Access Compliance Report

Public Rights-of-Way

(Curb Ramps)

Intersection ID: 20221	Main Street: BARCLAY_DOWNS_DR	Cross Street: FAIRVIEW_RD	Location: NE
ADA ID: 224CBB71B938	Ramp Type: PerpDiag	Initial Pass/Fail: Fail	Overall Compliance: No
Severity Score: 22.5			
Codes/Mitigation Info/Possible Solution		Field Measurements/Component Compliance

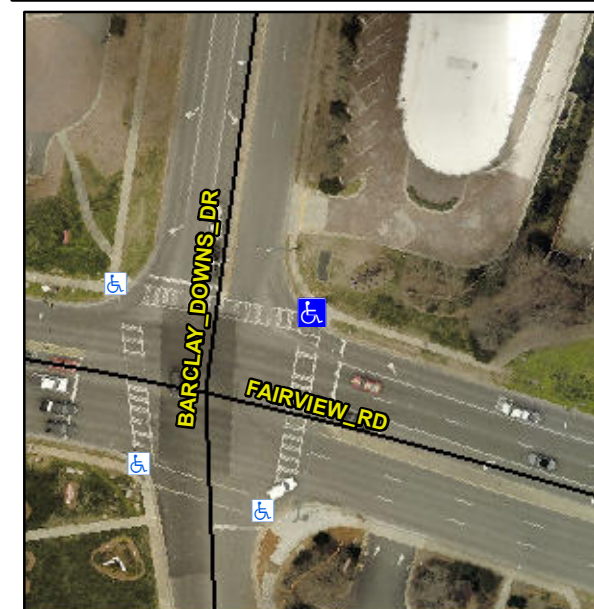
Not Found, R304.5.1, R304.2.2, R304.5.3

Compliance	Description	Data	Compliance	Description	Data
N/A	Ramp Length (in)	52.0	No	Ramp Slope (%)	10.0
No	Ramp Width (in)	46.0	No	Ramp XSlope (%)	3.2
N/A	Flare Type LT	N/A	N/A	Flare Type RT	N/A
N/A	Flare Slope LT (%)	N/A	N/A	Flare Slope RT (%)	N/A
N/A	Flare Traversable LT?	N/A	N/A	Flare Traversable RT?	N/A
N/A	Landing Length (in)	N/A	N/A	DWS Provided?	N/A
N/A	Landing Width (in)	N/A	N/A	DWS Contrast?	N/A
N/A	Landing Slope (%)	N/A	N/A	DWS Length (in)	N/A
N/A	Landing X Slope (%)	N/A	N/A	DWS Full Width?	N/A
N/A	Landing Curb? (Y/N)	N/A	N/A	DWS Offset (in)	N/A
N/A	Shared Landing?	N/A			
N/A	Gutter Ponding?	N/A	N/A	Gutter Slope (%)	N/A
N/A	Gutter Lip Ht (in)	N/A	N/A	Gutter X Slope (%)	N/A
N/A	Painted X Walk1?	Yes	N/A	Painted X Walk2?	Yes
	X Walk 1 Direction	To NW		X Walk 2 Direction	To SW
N/A	X Walk 1 Width (in)	103.0	N/A	X Walk 2 Width (in)	114.0
	X Walk 1 Slope (%)	2.2		X Walk 2 Slope (%)	0.3
	X Walk 1 X Slope (%)	0.1		X Walk 2 X Slope (%)	0.9

N/A	Ramp inside XWalk1?	Yes	N/A	Ramp inside XWalk2?	Yes
	Road Slope (%)	0.5	N/A	Clear Space?	N/A
	Road X Slope (%)	0.1	N/A	Clear Space to XWalk (in)	N/A
N/A	Any Obstructions?	N/A	N/A	Storm Grate/Utility Hazard?	N/A
	Obstruction Type			Storm Grate/Utility Type	
		N/A			N/A
		Yes		Surface Condition? (G/P)	Good

Remove & Replace Curb Ramp With Two New Directional Ramps or Equivalent.
